RE: Curtis H. Stanton Energy Center Unit B IGCC  
PSD Permit No. PSD-FL-373

**Attachment 1**  
**Updated Facility Design Drawings**

**Stanton Unit B**  
**Revised Class II Modeling – June 2007**

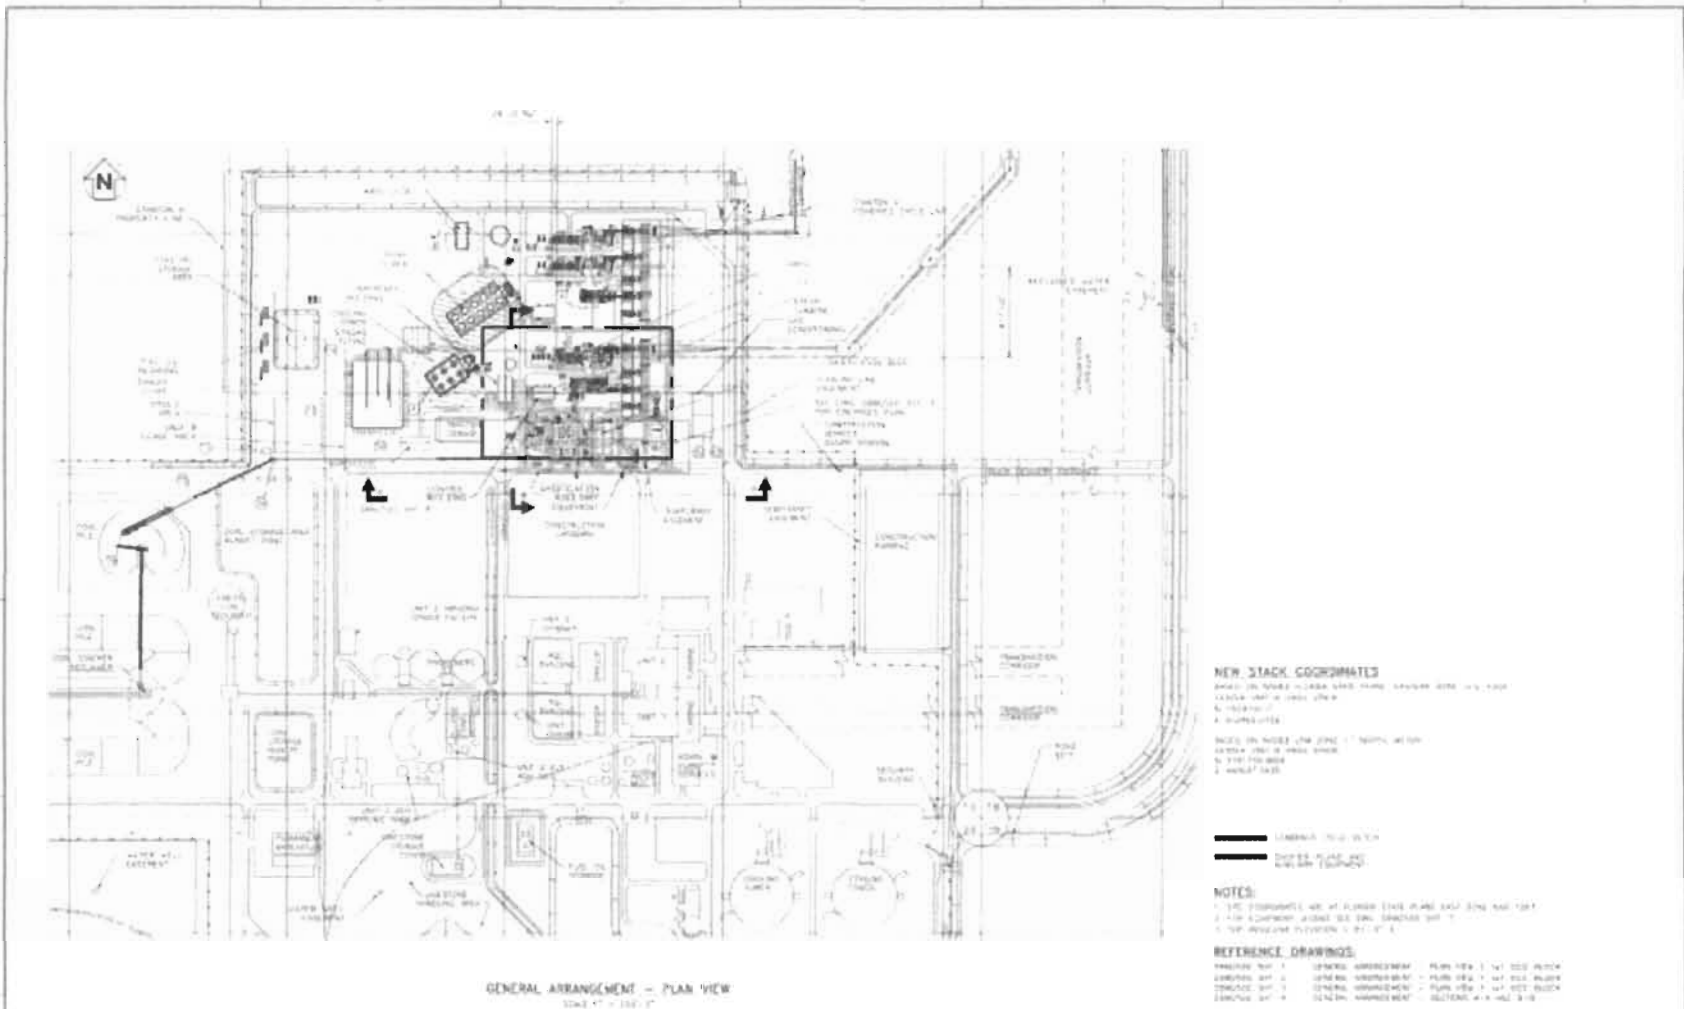
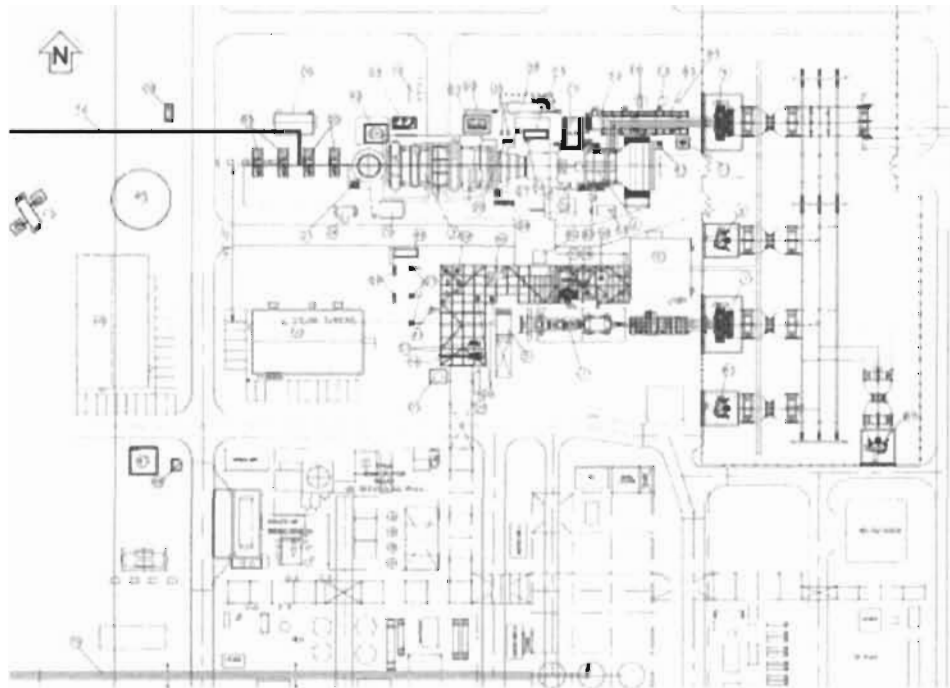
1. This project will require construction of a single gasifier vessel instead of two gasifier vessels. The coal input to and the syngas output from the single gasifier will be the same as presented in the original application as the total for the two gasifiers. A single gasifier is shown on the site drawings included in Attachment 1. With a single gasifier as opposed to two gasifiers, emissions during gasifier startup will remain within the estimates presented in the original application and will most likely be reduced.

2. This project will require certain site layout revisions in order to optimize the design and performance of the unit. Upon the conclusion of FEED, several structure heights and locations have been revised. These revisions are indicated in the design drawings located in Attachment 1. A revised air dispersion modeling study has been conducted considering the new layout and its results are included in Attachment 2. Impacts from all pollutants modeled remain below applicable modeling significance levels.

The overall result of these updates is that the number of emission points from the system is reduced, as are the total emissions from the system. These changes have been reflected in the drawings in Attachment 1 and in the revised dispersion modeling included in Attachment 2.
